PIC18F6620/8620/6720/8720

PIC18F6620/8620/6720/8720 Rev. A3 Silicon/Data Sheet Errata

The PIC18F6620/8620/6720/8720 parts you have received conform functionally to the Device Data Sheet (DS39609B), except for the anomalies described below.

FIGURE 26-3: PIC18F6620/6720/8620/8720 VOLTAGE-FREQUENCY GRAPH (INDUSTRIAL, EXTENDED)

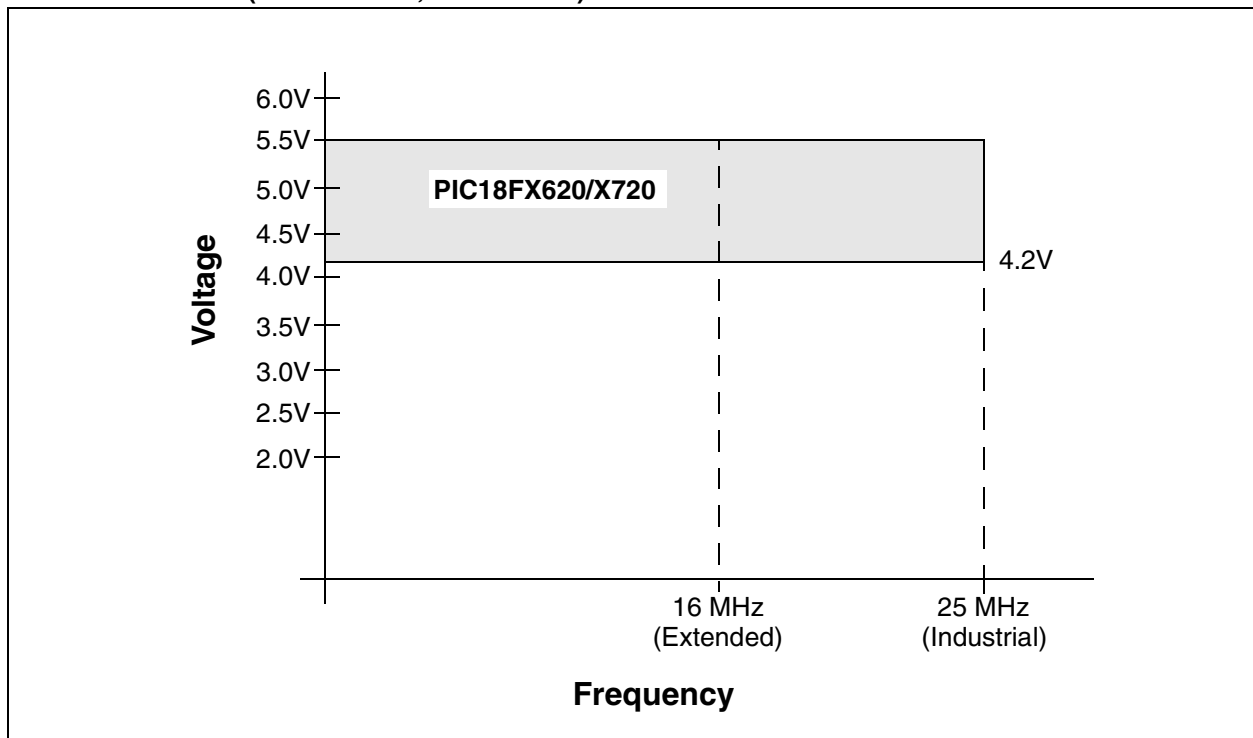
In Section 26.0 “Electrical Characteristics”, the following figure has been updated to clarify the voltage frequency for extended devices.

FIGURE 11-1: TIMER0 BLOCK DIAGRAM IN 8-BIT MODE

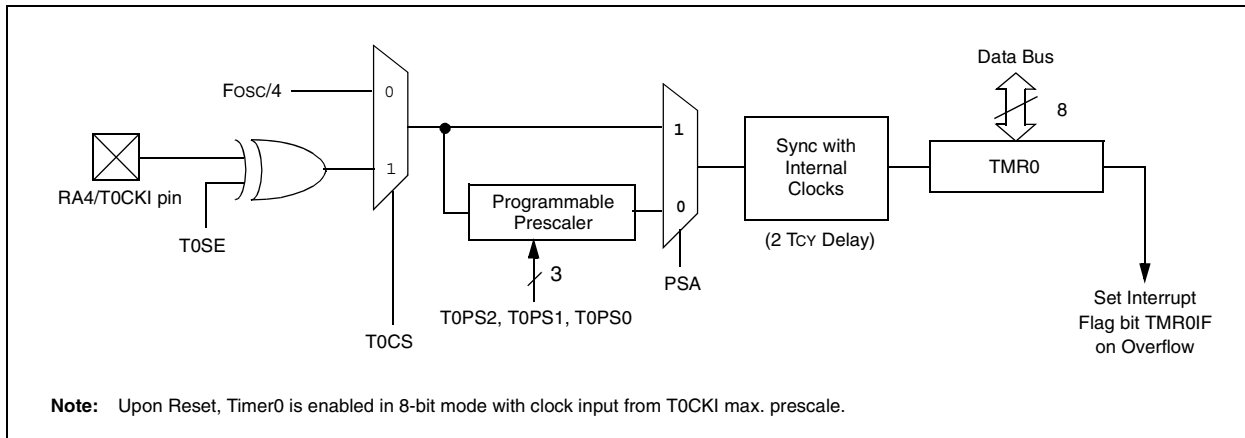
The PSA multiplexor bit values in Figures 11-1 and 11-2 do not match the text description of the Timer0 PSA bit in the T0CON register.

The bit values have been corrected by swapping the values as shown below (correct values are shown in **bold text**):
